Technical Service Bulletin: TSB190225	Released Date: 12-Jan-2022
Expired Campaign #4035: Fix for C100D2RE Generator Set Paralleling Control Wiring Issue

Expired Campaign #4035: Fix for C100D2RE Generator Set Paralleling Control Wiring Issue

Figure 1, Harness A054R546 with P70 and J40 highlighted

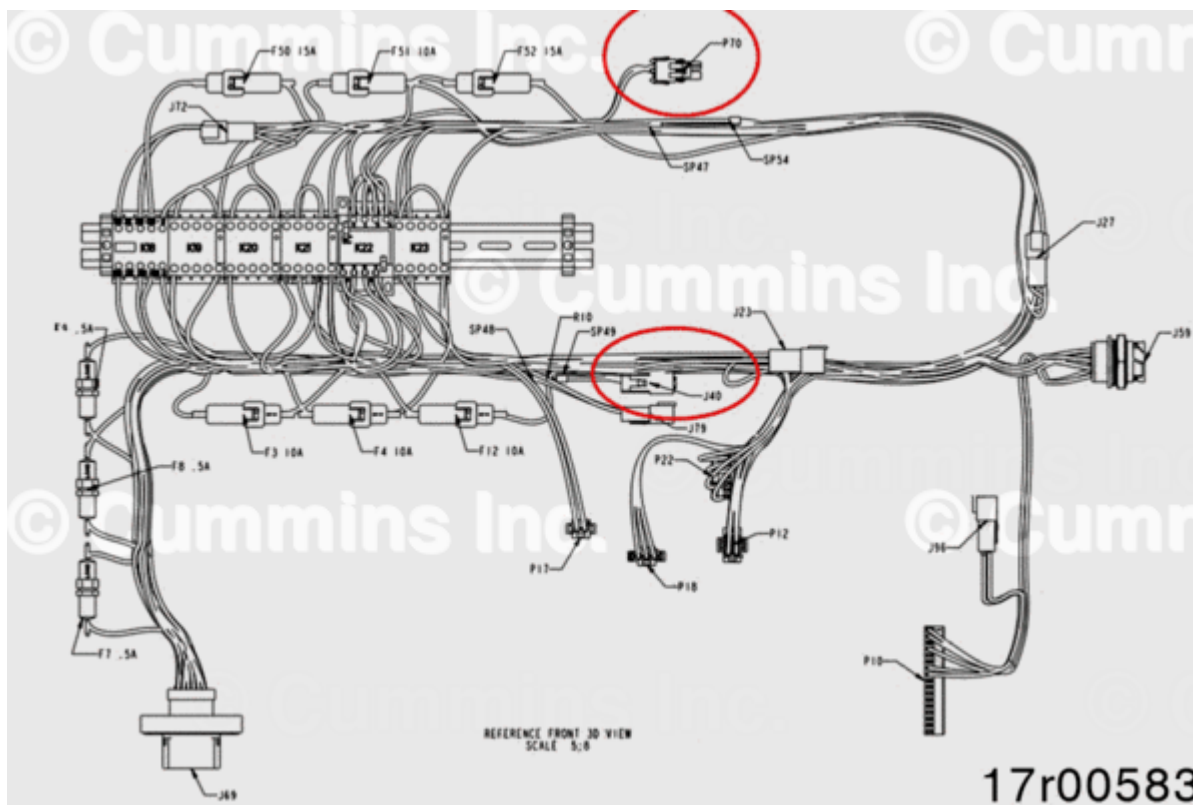
When a C100D2RE generator set is attempted to parallel with a C150, C200 or C275 generator set, the B+ (24 VDC) on the two units short with each other, as a result of which the units cannot be paralleled, and temperature of the paralleling cable rises.

- Due to a design error in C100D2RE generator set harness, paralleling C100 with any other models causes the B+ (24 VDC) from one unit to be shorted to B+ on the other unit

On the harness of C100D2RE (PN: A054R546) shown in Figure 1 below:

1. Swap P70-A and P70-B
2. Swap J40-1 and J40-2

Figure 2, Location of connectors P70 and J40 on harness

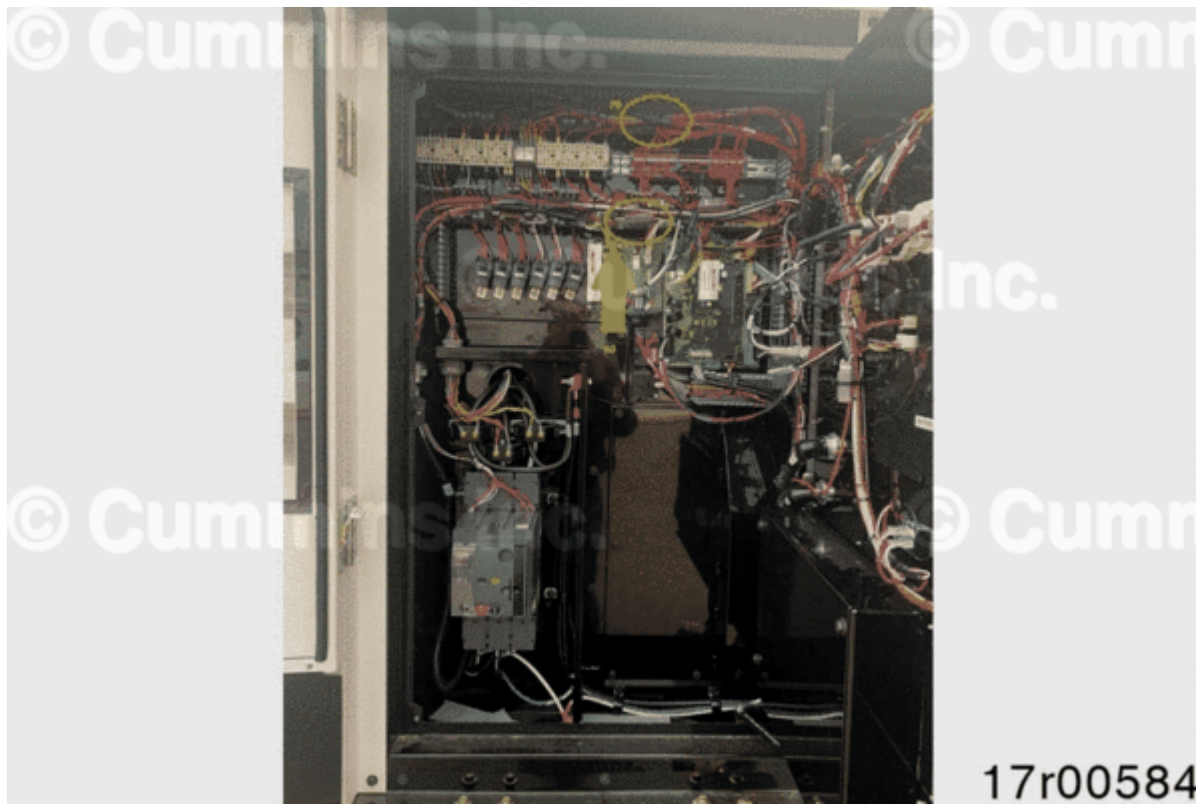
The harness is in the front panel inside the top rack of generator set. To locate connectors P70 and J40 with respect to the harness, refer to Figure 2.

Figure 6, Harness A054R544 showing location of connectors J66A and TB3

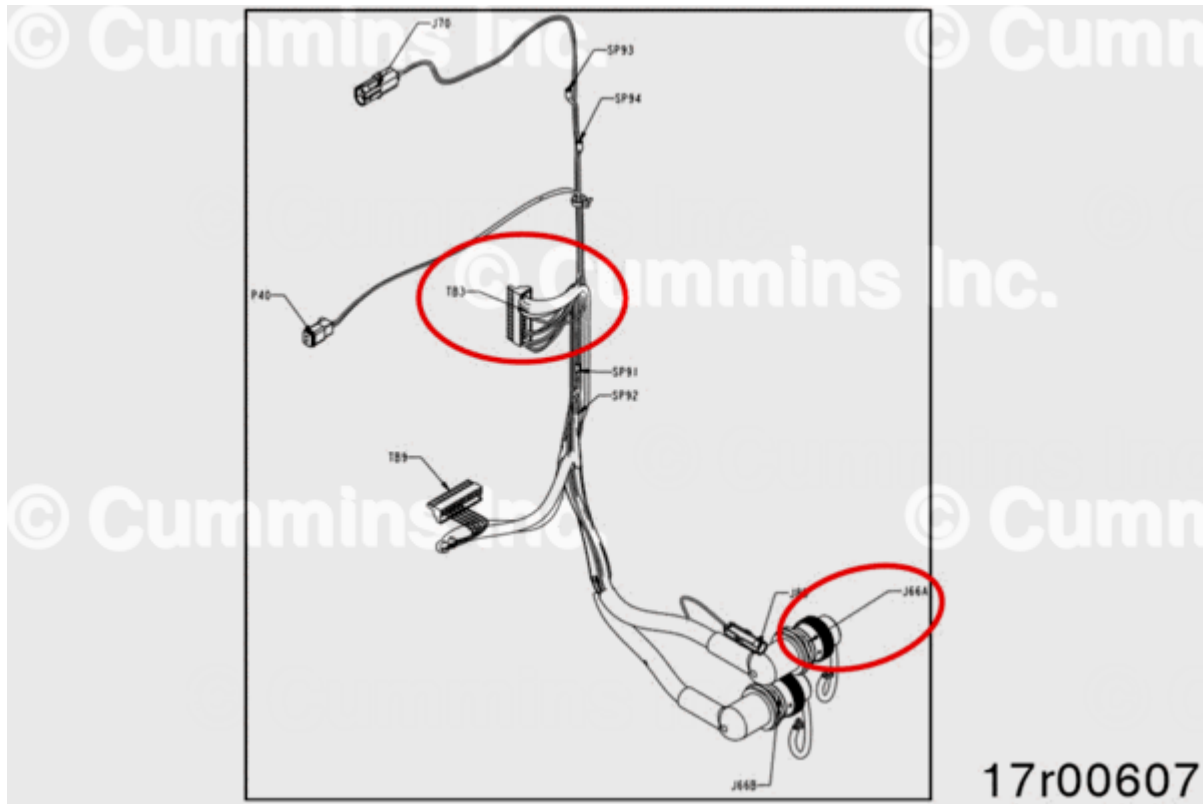
Confirm the fix performed above by checking for continuity on the terminals between harnesses A054R544 (Figure 6) and A054R546 (Figure 1) indicated in Table 1, by using a multimeter.

Table 1, Terminals and resistance values to be checked for continuity on harnesses A054R544 and A054R546		
S. No.	Terminals	Resistance value required to indicate continuity
1	From J66A-12 to K23A-1	0 -1 ohm
2	From J66A-13 to K23A-2	0 -1 ohm
3	From TB3-5 to K20A-2	0 -1 ohm
4	From TB3-11 to K20-14	10k ohm
